Hayman House Plans Review

Subject: ADA Compliance Review of Erma Hayman House Restoration Design Plans

Erma Hayman House Restoration

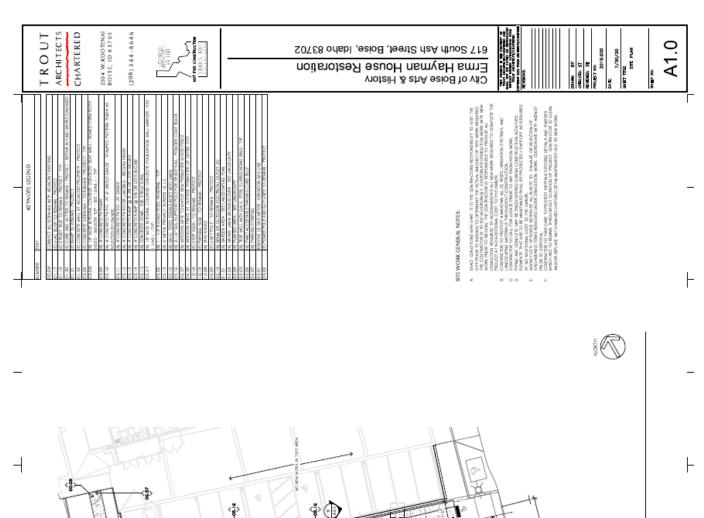
| Drawing/ | Erma Hayman House Restoration Design | ADAAG Requirements |
|--------------------------|---|---|
| A0.0 | CODE DATA: | 28 CFR §35.151. Construction and/or |
| Cover | Suggest adding "USDOJ 2010 ADA Standards | alteration of existing facilities are governed by the accessibility regulations enforced by |
| | for Accessible Design (9.15.2010)" | the U.S. Department of Justice |
| A0.0 Cover | GENERAL BUILDING CODE NOTES: | §36.405 Alterations: Historic preservation. |
| Cover | The notes state, "This building is considered eligible for listing in the National Register of Historic Places." The ADA requires full compliance with the accessibility requirements for any elements altered during the project unless it is not feasible due to structural or threat to the historic significance of the facility. | (a) Alterations to buildings or facilities that are eligible for listing in the National Register of Historic Places under the National Historic Preservation Act (16 U.S.C. 470 et seq.) or are designated as historic under State or local law, shall comply to the maximum extent feasible with this part. |
